Smart Tachograph v2

COMMISSION IMPLEMENTING REGULATION (EU)

amending Implementing Regulation (EU) 2016/799 as regards the requirements for the construction, testing, installation and inspection of smart tachographs and their components

Figure 2

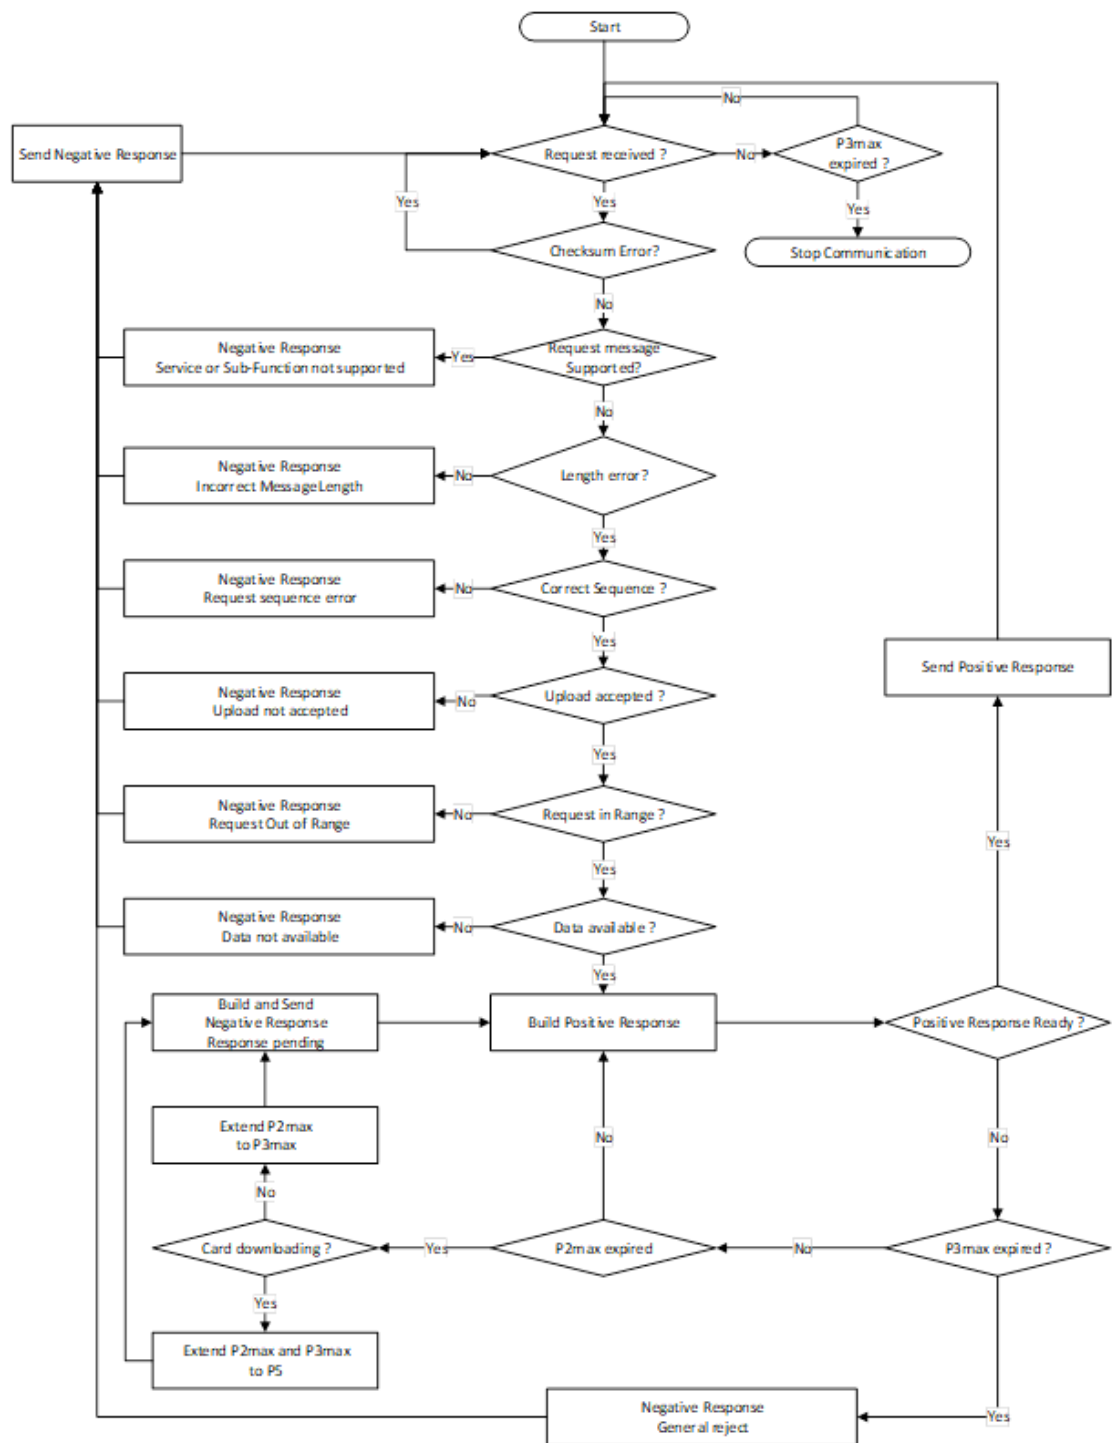
(iv) in point 2.2.5.2, Figure 2 is replaced by the following:

Figure 7

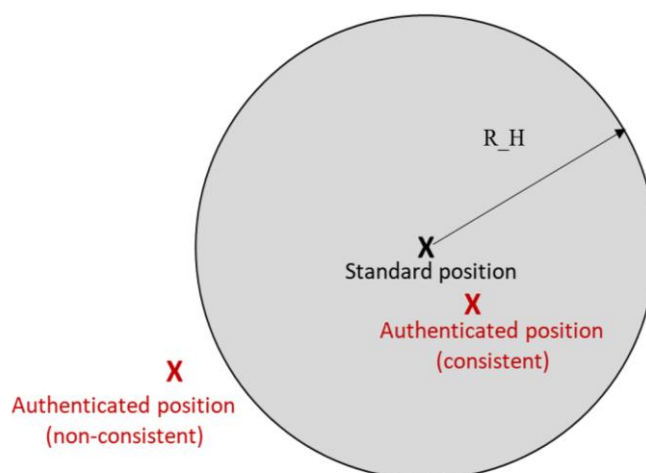
Authenticated and standard positions are considered as consistent, as shown in Figure 7, when the horizontal authenticated position can be found in a circle centred at the horizontal standard position, which radius results of rounding up to the nearest upper whole number the value of R_H calculated according to the following formula:
